**Flood Control Project Maintenance  
Levee Inspections**

**Fall 2017 Levee Maintenance Deficiency Summary Report**

**Reclamation District No. 0765 Glide**

**Levee Inspection Report By Mile - Fall 2017**

Photo 1 of 1 : FA\_2017\_RD0765\_211\_1\_20170919\_00070.jpg

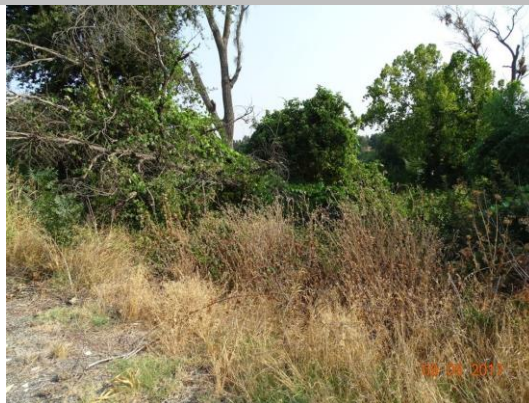
LM Start	1.58	Rating **	U	Issue No.	1
LM End	1.58	Issue Type +	Ma	Location *	WS
Category	Earthen Levee			GPS Latitude/Longitude	
				Start	End
Item	Encroachments			38.481959 °	38.481959 °
				-121.550527 °	-121.550527 °
DWR ID	DWR_RD0765_01_f_2017_1				
Comment Code					
TR : Tree or limb					
Inspector Comment					
Downed tree on waterward slope
